MESA DEL SOL
ARCHITECTURAL CONTROL COMMITTEE
SITE DEVELOPMENT PLAN REVIEW

MESA DEL SOL SELF STORAGE
SITE PLAN
5500 TURING DR SE
ALBUQUERQUE, NM 87106
PROJECT #2322

**RE: Mesa Del Sol Self Storage
5500 Turing Dr. SE
Grading and Drainage Plan
Engineer's Stamp Date: 5/7/2025
Hydrology File: R16DA1004**

**Re: Mesa Del Sol Self Storage
 5500 Turing Dr. SE
 Grading and Drainage Plan
 Engineer's Stamp Date: 01/15/2025
 Hydrology File: R16DA1004**

PROJECT NUMBER

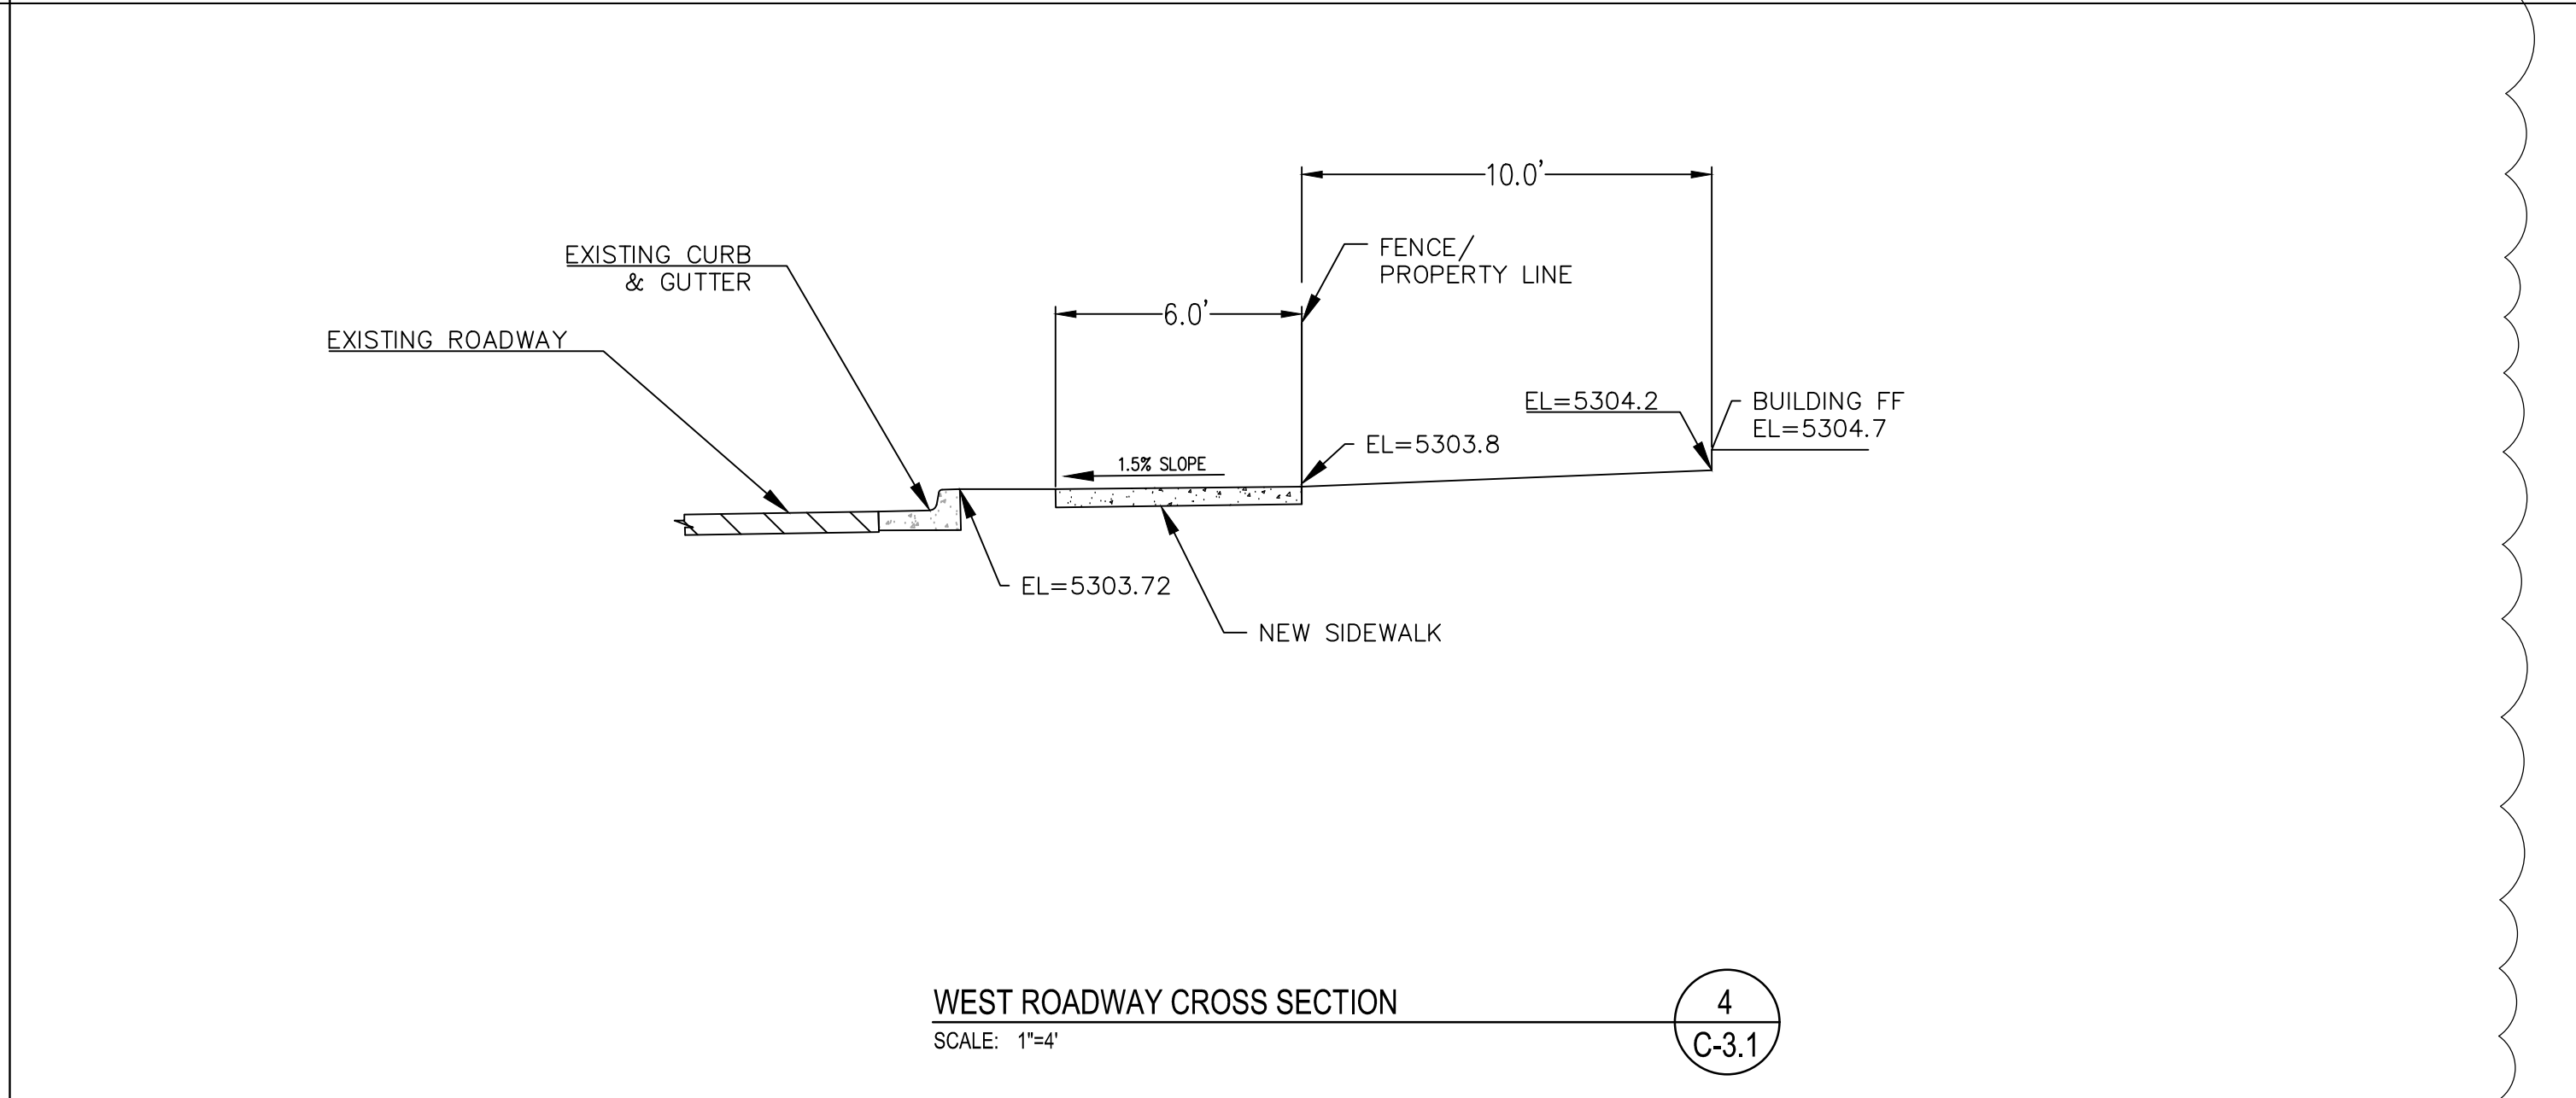
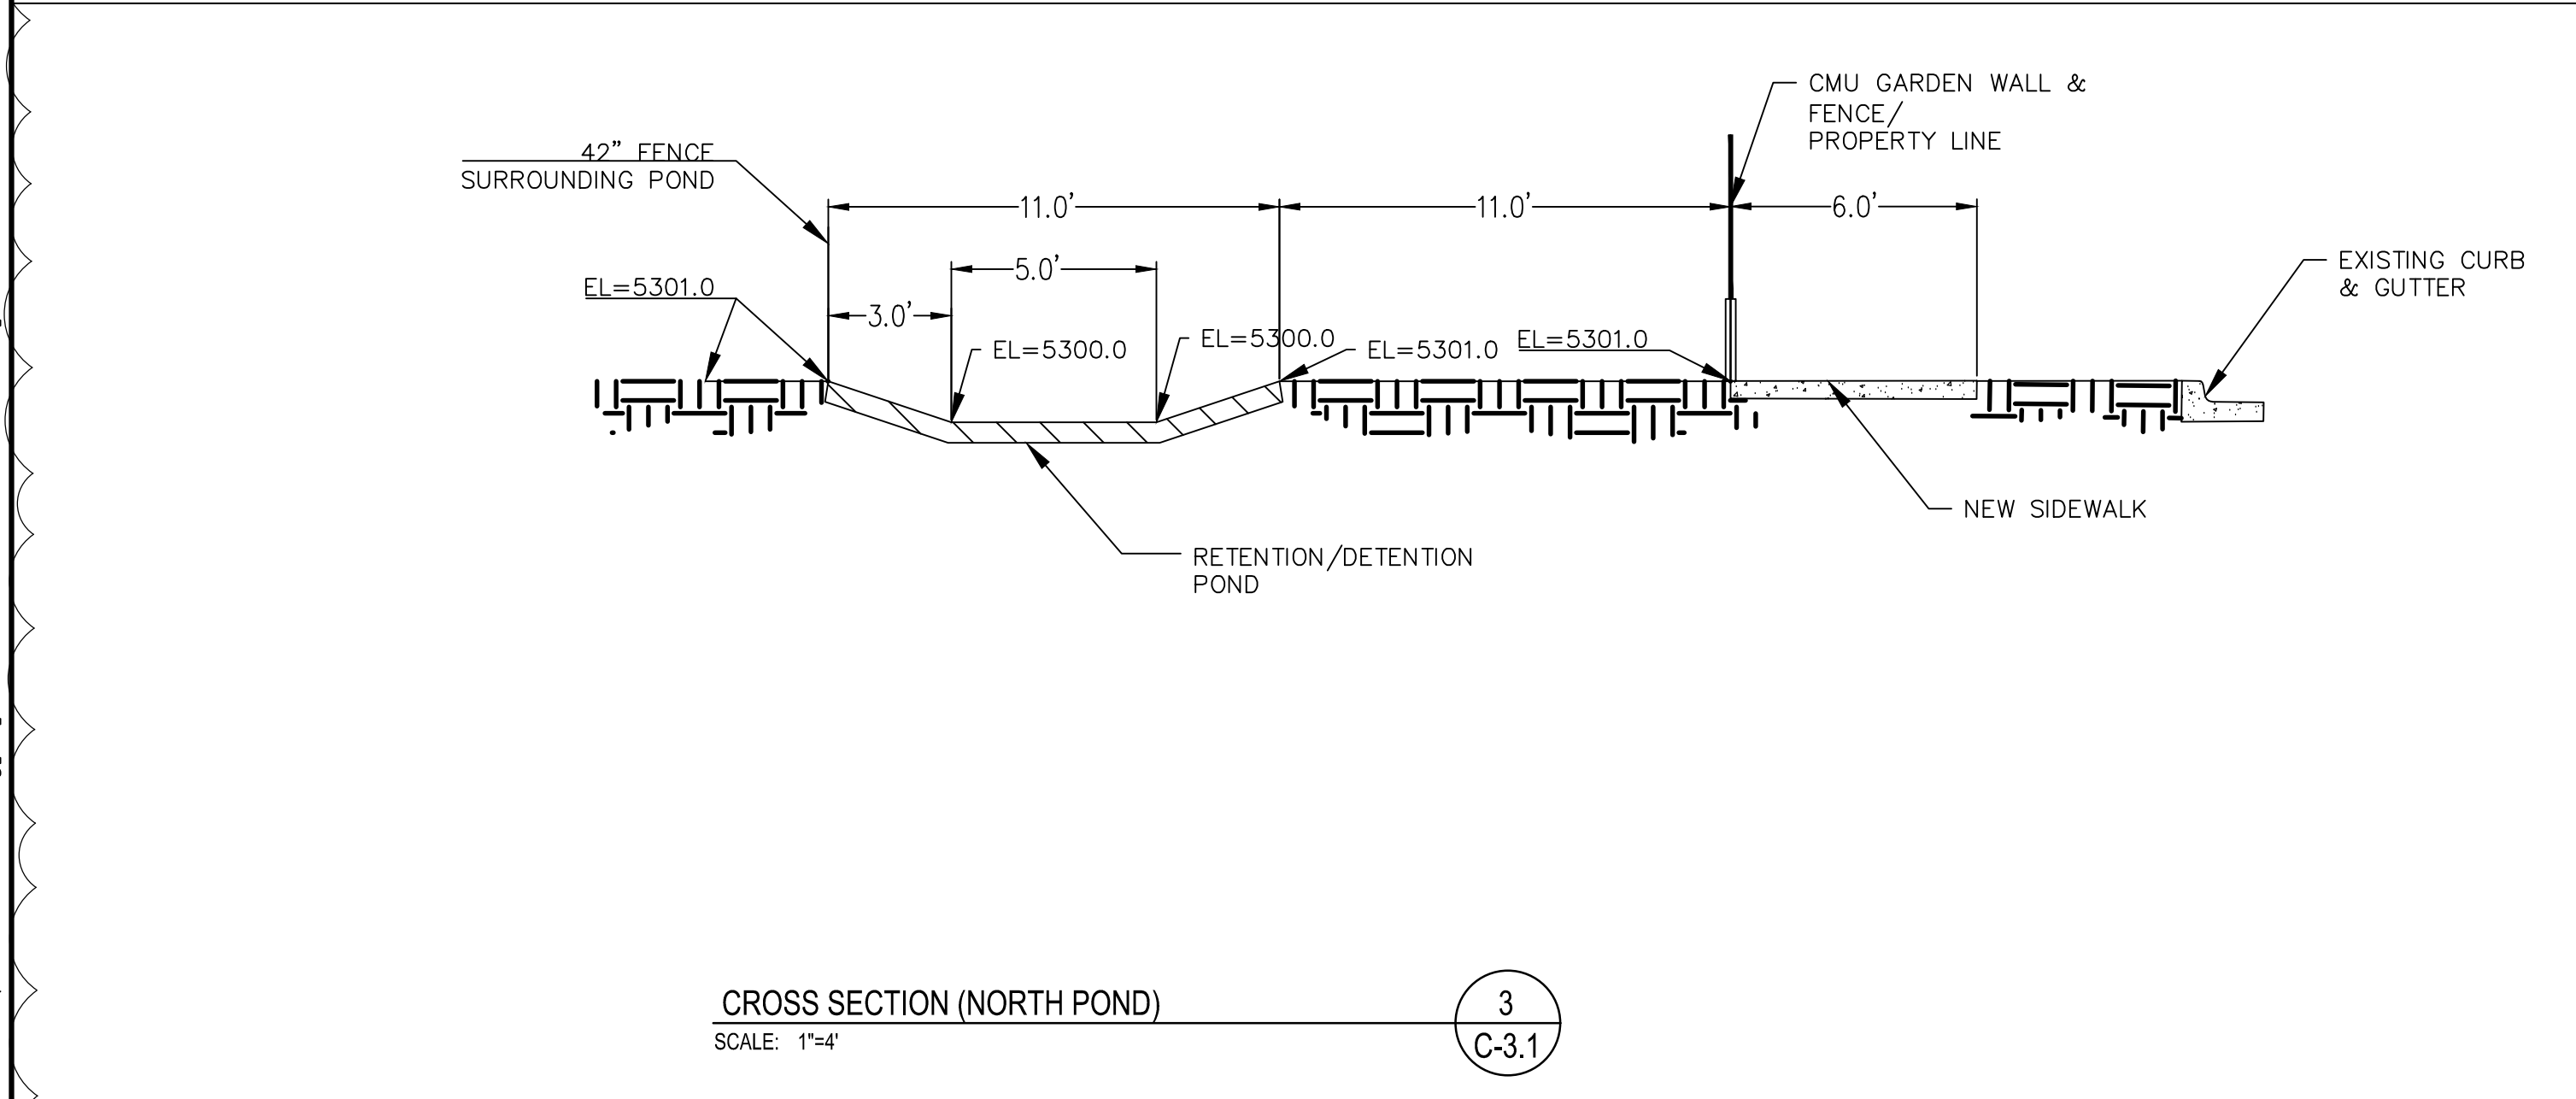
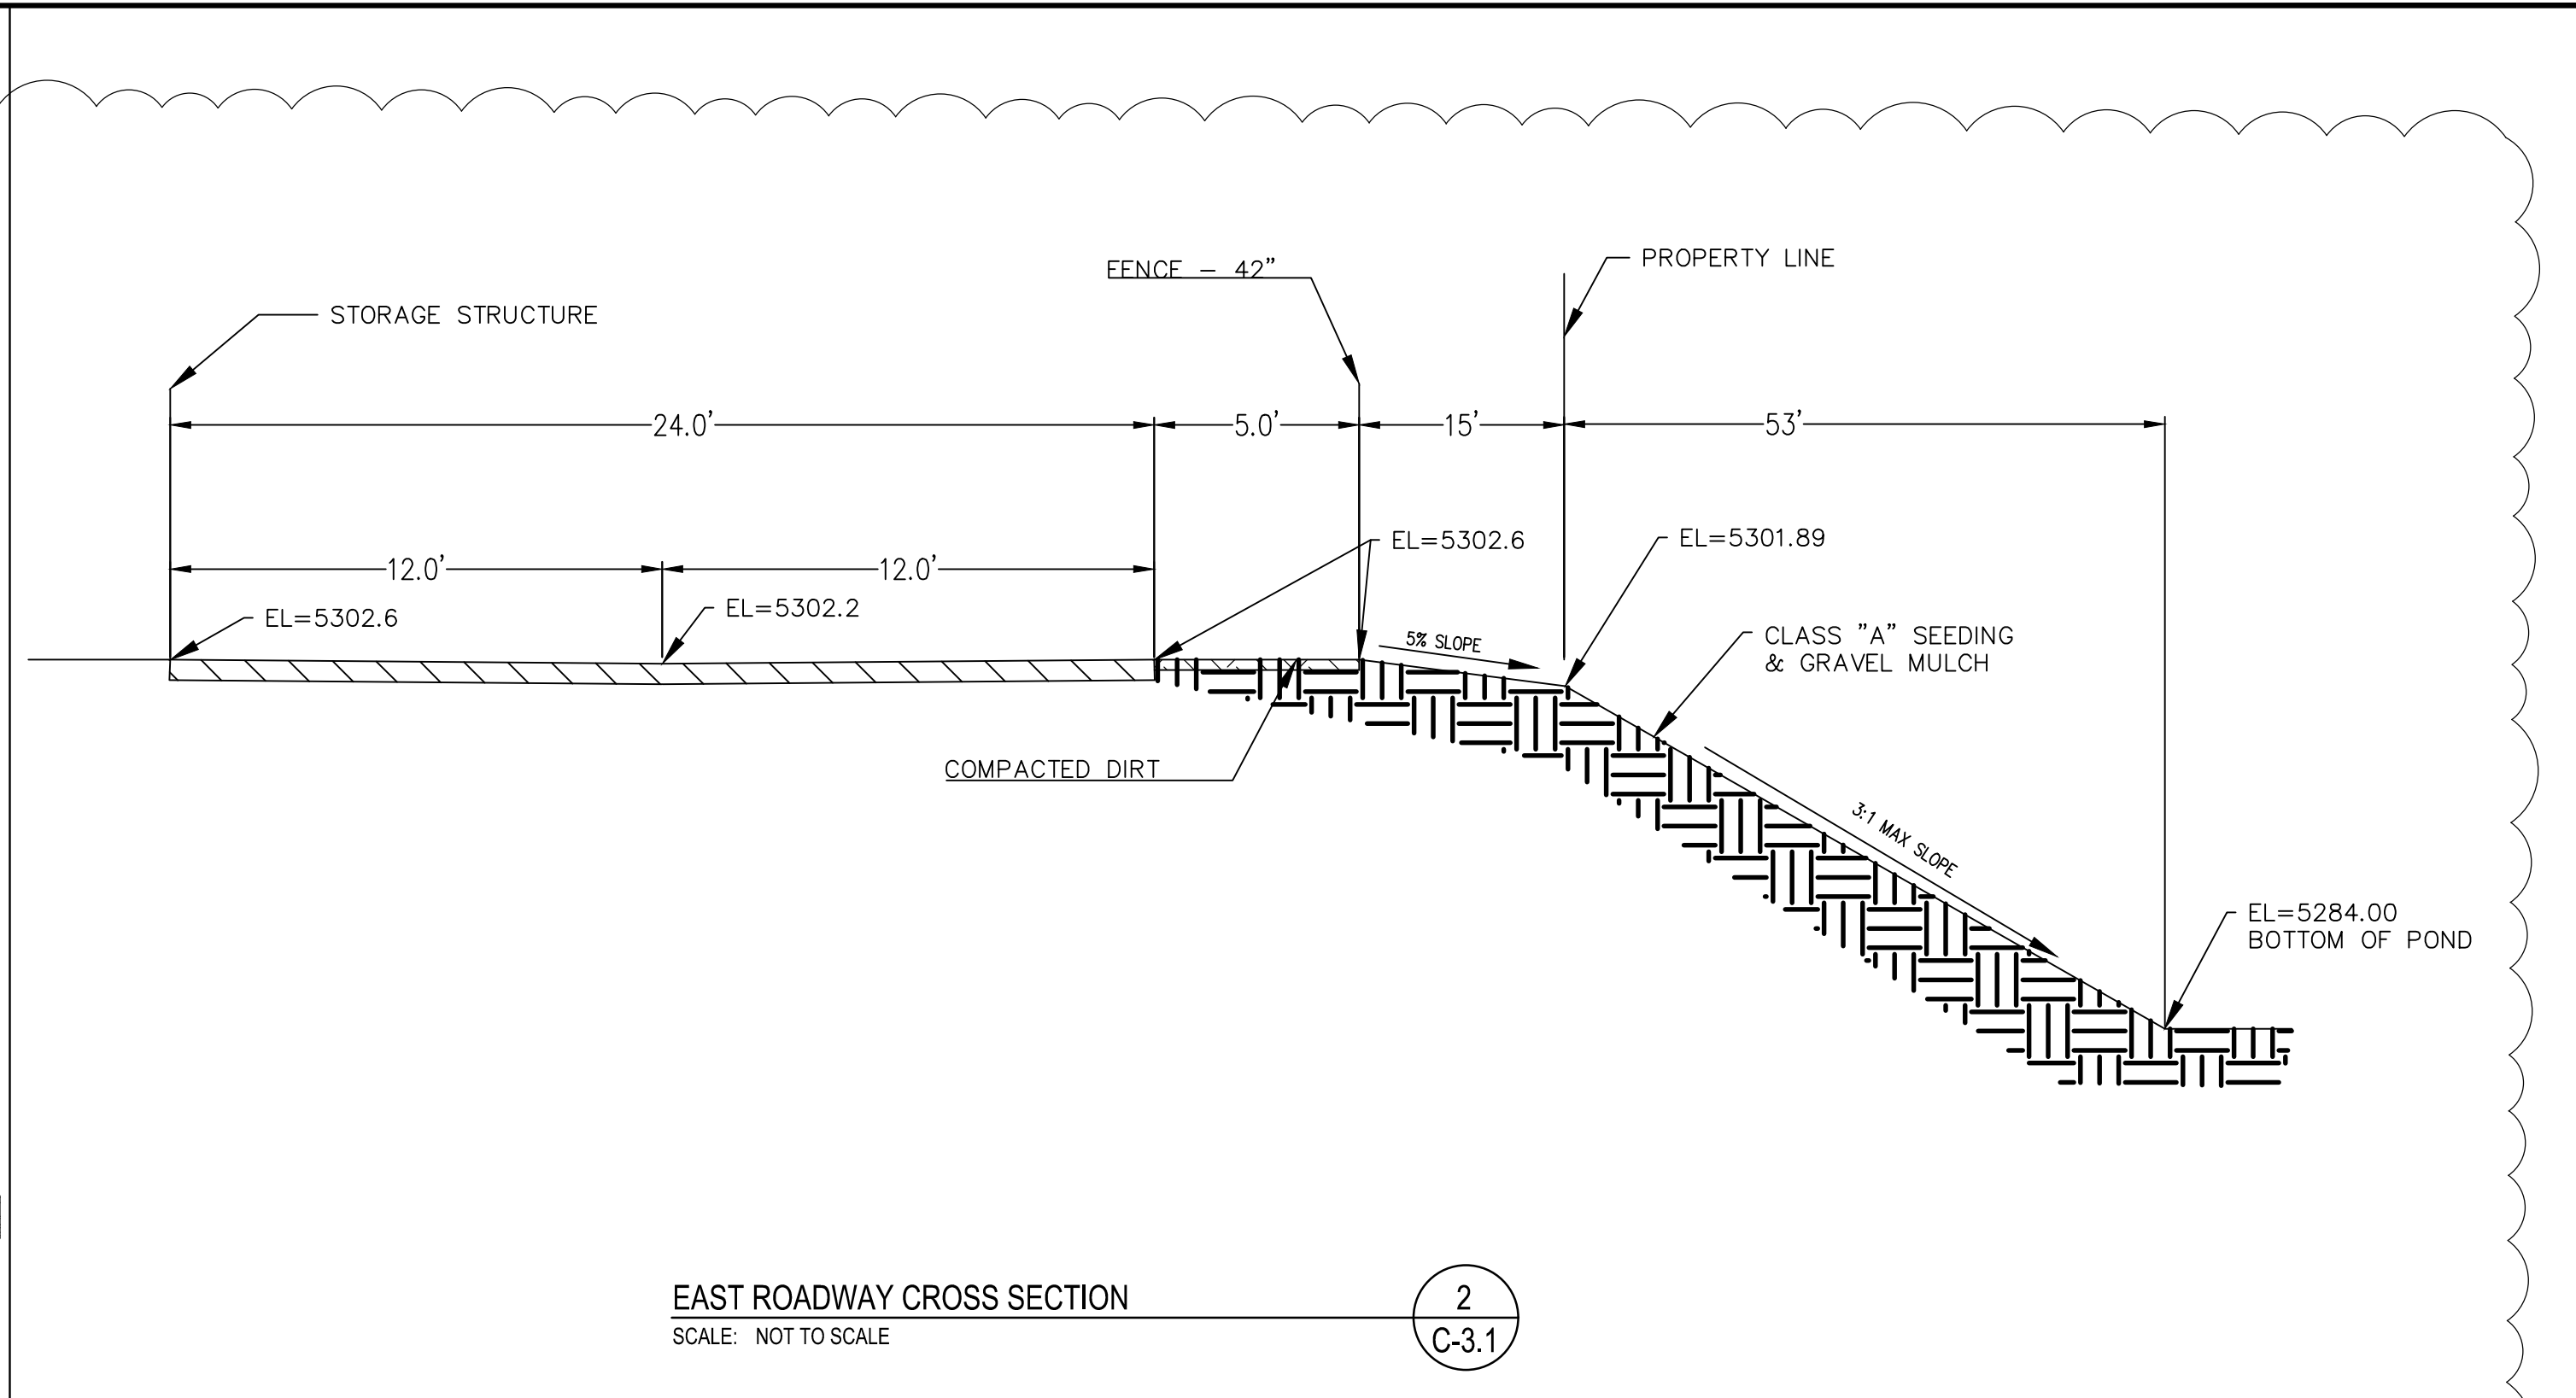
REVISIONS	NO.	BY	DATE	REMARKS
	1	NV5	5/7/25	HYDROLOGY COMMENTS DATED 3/21/25
